Audit of Reclaim Protocol's ChaCha20 Circuit

September 23rd, 2023

On July 31st, 2023, zkSecurity was tasked to audit Questbook's ChaCha20 circuits for use in the **Reclaim Protocol**.

2 - Unsound XOR gadget

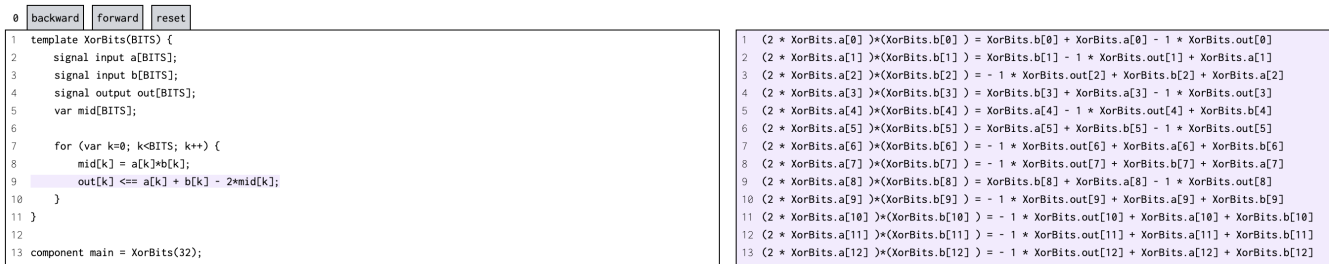
Description. The `XorWords` gadget constraints the XOR of two arrays of `M`-bit values (for some fixed array size and value `M`).

In order to implement the XOR in-circuit, the logic implements the XORs bit by bit. It was found that the bit constraints for the witness values were commented at the time of the audit:

```
abits[l] <-- ain >= j ? 1 : 0;
bbits[l] <-- bin >= j ? 1 : 0;
// ensure abits[l] and bbits[l] are either 0 or 1
// below should be uncommented in prod?
// abits[l] * (abits[l] - 1) === 0;
// bbits[l] * (bbits[l] - 1) === 0;
xors[l] <== abits[l] + bbits[l] - 2 * abits[l] * bbits[l];
```

In addition, the bit decomposition of both operands `a` and `b` must be constrained to be correct. While the gadget's logic attempt to do just that, it was found that the check was flawed.

As you can see, the last check constraints that `ain * a[i] == 0`. This is true if either `ain = 0` or `a[i] == 0`.

What we really want to check is that `ain = 0`, but the check doesn't apply if the value of `a[i]` is 0.

In the case where the value of `a[i]` is 0, then a malicious prover can use an arbitrary bit decomposition for `a[i]`.

Recommendations. Use **circomlib's Num2Bits** function to convert both operands to bitstrings.

Client response. The client fixed the issue by enforcing an XOR constraint ($\mathrm{res} = \mathrm{a} + \mathrm{b} - 2\mathrm{ab}$) on each bits individually. As one can see using zkSecurity's **circomscribe tool** (introduced **here**), the constraint is correctly enforced by the circuit (which includes correctly constraining the quadratic term):
